Application No. 10/568,784  
Amendment dated June 5, 2007  
Reply to Office Action of January 5, 2007

Amendments to the Drawings

FIG. 2.

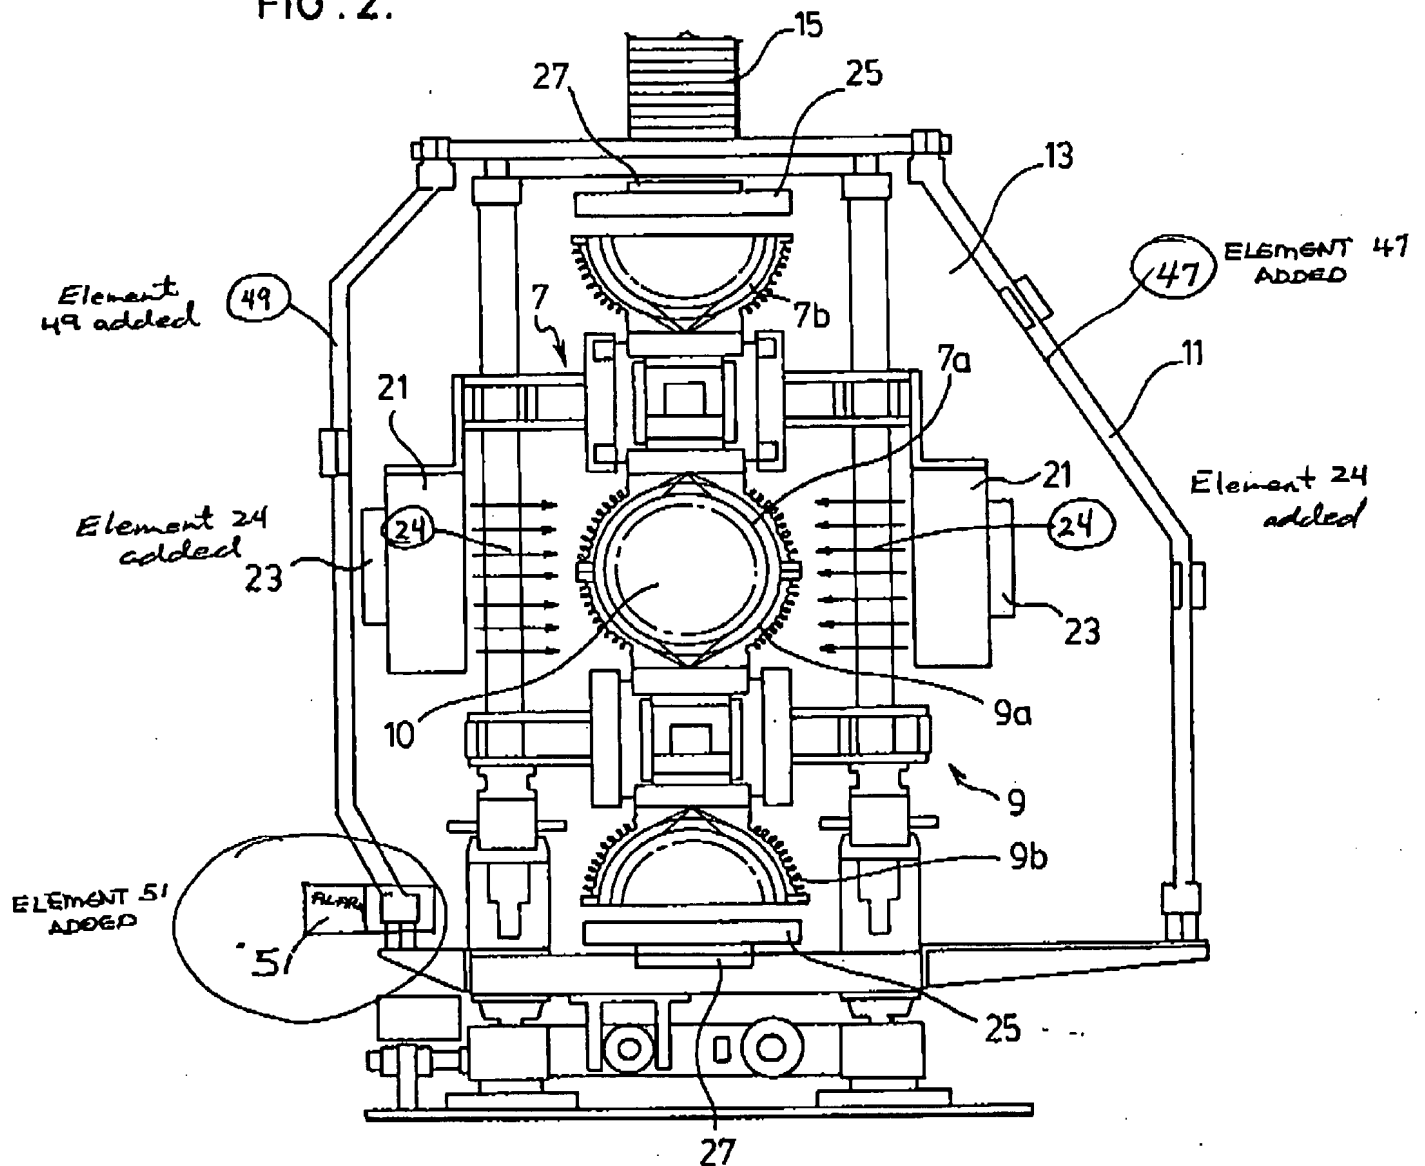
The attached sheets of drawings include changes to Figures 1, 2 and 3. These sheets of drawings replace the previously submitted sheets containing each of these Figures. Element 12 in Figure 1 has been replaced with element 21. Elements 24, 47, 49 and 51 have been added in Figure 2. Element 3 in Figure 3 has been replaced with element 31.
